SUBJECT: Forwards rev to Section 8 of Cycle 3 reload analysis rept.

Subject: Palo Verde Nuclear Generating Station (PVNGS)  
Unit 1  
Revision to Section 8 of Reload Analysis  
Report for Unit 1, Cycle 3  
File: 89-E-056-026

SUBJECT: SUMMARY OF MEETING WITH THE COMBUSTION ENGINEERING OWNERS  
GROUP (CEOG) REGARDING THE DEFAS DESIGN FEATURES TO BE  
INSTALLED PER 10 CFR 50.62 (THE ATWS RULE)

3410 MWT PLANT CLASS  
LOFW ATWS  
PEAK PRESSURE VERSUS MODERATOR TEMPERATURE COEFFICIENT

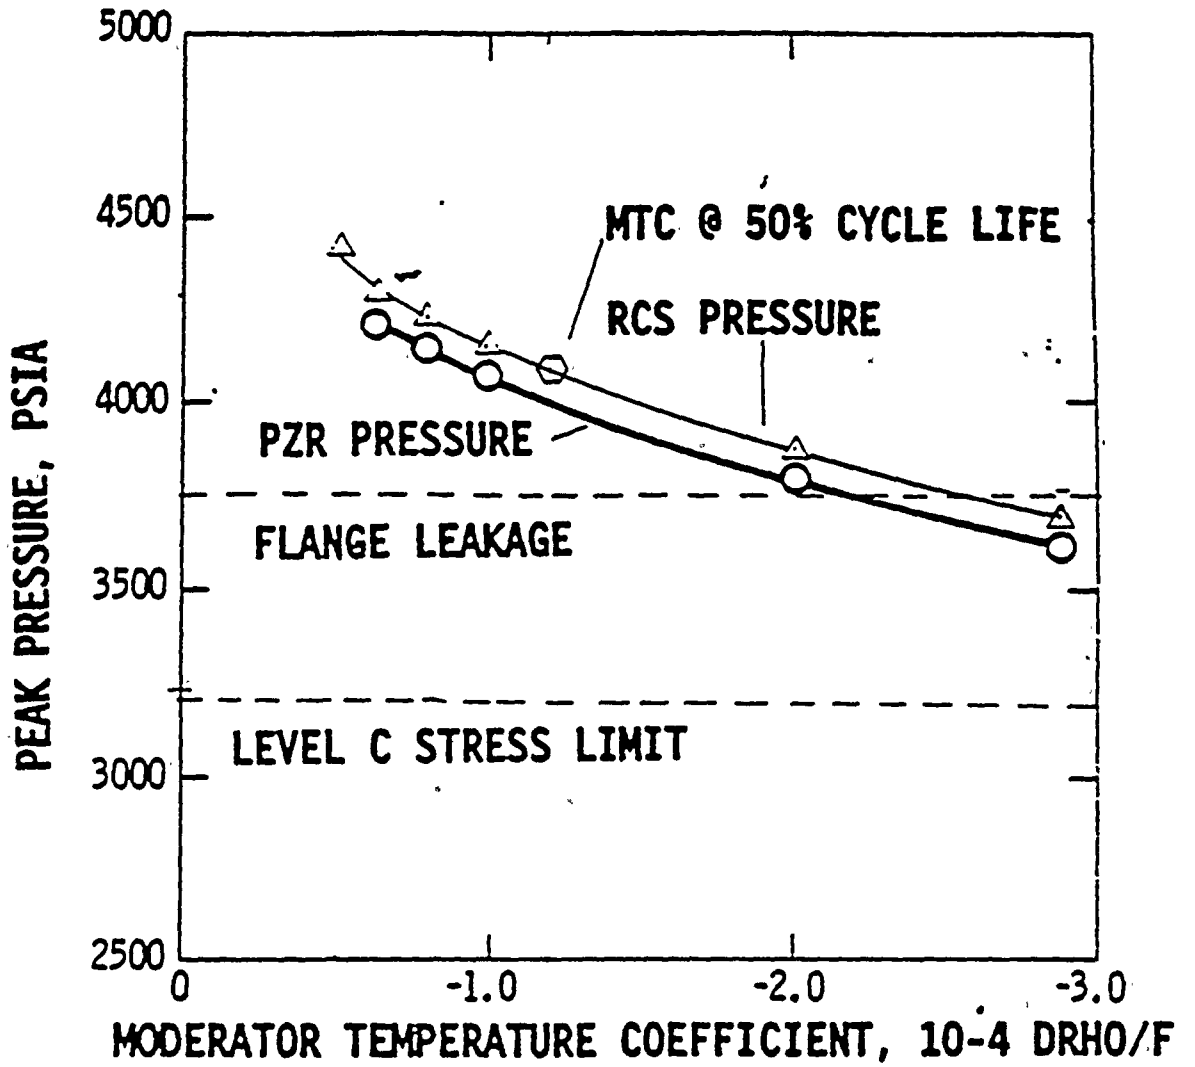
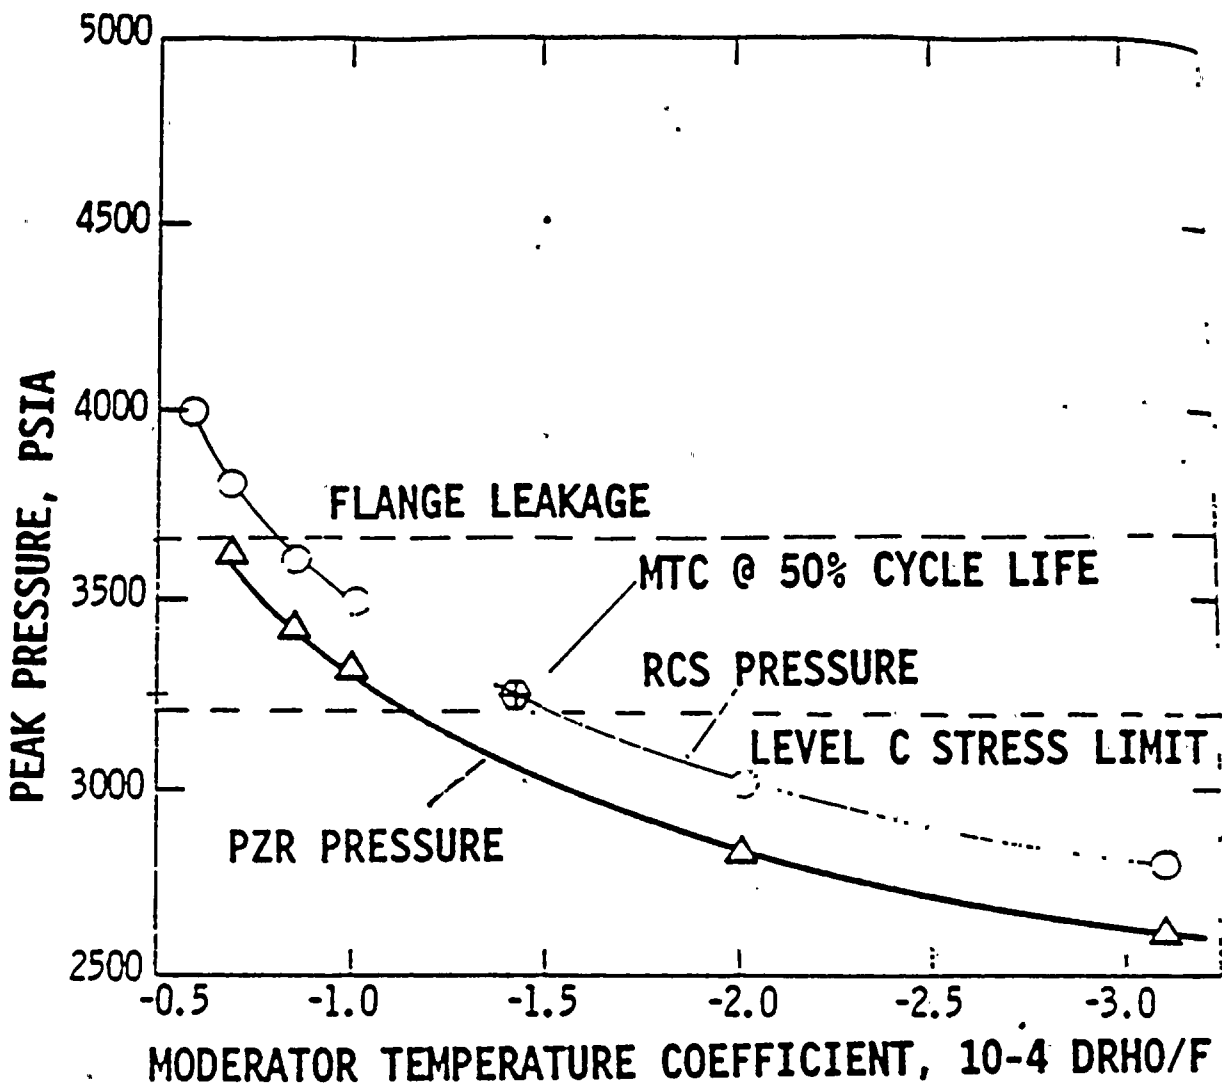
QUESTION 2

PROVIDE A DISCUSSION OF SGLL AS AN ALTERNATIVE TO THE DSS INTERLOCK

REAL ISSUE

WILL EARLIER AUX. FEED ACTUATION MITIGATE AN ATWS EVENT FOR LATER TIMES IN THE CYCLE

FOR LIMITING ATWS SCENARIO, AUX. FEED TIMING HAS LITTLE IMPACT ON PEAK PRESSURE

FOR THE 3410 MW<sub>T</sub> CLASS THERE IS NO TIME IN THE CYCLE WHICH YIELDS ATWS PEAK PRESSURES BELOW LEVEL C STRESS LIMITS (CENPD-263)

FOR THE 3800 MW<sub>T</sub> CLASS THERE MAY BE A SMALL IMPACT ON PEAK PRESSURE FOR LATER TIMES IN CORE CYCLE, I.E., BELOW LEVEL C STRESS LIMITS (CENPD-263)
